## Access Compliance Report Public Rights-of-Way (Curb Ramps)

Intersection ID: 52624Main Street: CORMWELL\_LNCross Street: CONTEMPORARY\_PLLocation:SADA ID: DA1AFEB637ACRamp Type: PerpInitial Pass/Fail: FailOverall Compliance: NoSeverity Score:25

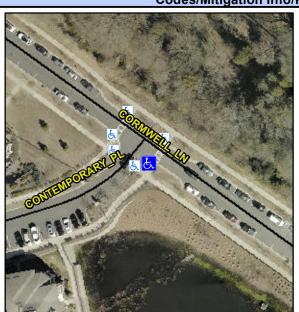
Not Found, R304.2.2, R304.5.3

Field Measurements/Component Compliance							
Comp	liance Description	Data	Comp	liance	Description	Data	
N/A	Ramp Length (in)	68.0	No	Ramp	Slope (%)	9.1	
Yes	Ramp Width (in)	60.0	No	Ramp	XSlope (%)	5.8	
N/A	Flare Type LT	N/A	N/A	Flare	Type RT	N/A	
N/A	Flare Slope LT (%)	N/A	N/A	Flare	Slope RT (%)	N/A	
N/A	Flare Traversable LT?	N/A	N/A	Flare	Traversable RT?	N/A	
N/A	Landing Length (in)	N/A	N/A	DWS	Provided?	N/A	
N/A	Landing Width (in)	N/A	N/A	DWS	Contrast?	N/A	
N/A	Landing Slope (%)	N/A	N/A	DWS	Length (in)	N/A	
N/A	Landing X Slope (%)	N/A	N/A	DWS	Full Width?	N/A	
N/A	Landing Curb? (Y/N)	N/A	N/A	DWS	Offset (in)	N/A	
N/A	Shared Landing?	N/A					
N/A	Gutter Ponding?	N/A	N/A	Gutte	r Slope (%)	N/A	
N/A	Gutter Lip Ht (in)	N/A	N/A	Gutte	r X Slope (%)	N/A	
N/A	Painted X Walk1?	Yes	N/A	Paint	ed X Walk2?	N/A	
	X Walk 1 Direction	To NE		X Wa	lk 2 Direction	N/A	
N/A	X Walk 1 Width (in)	64.0	N/A	X Wa	lk 2 Width (in)	N/A

Remove & Replace Entire Ramp.
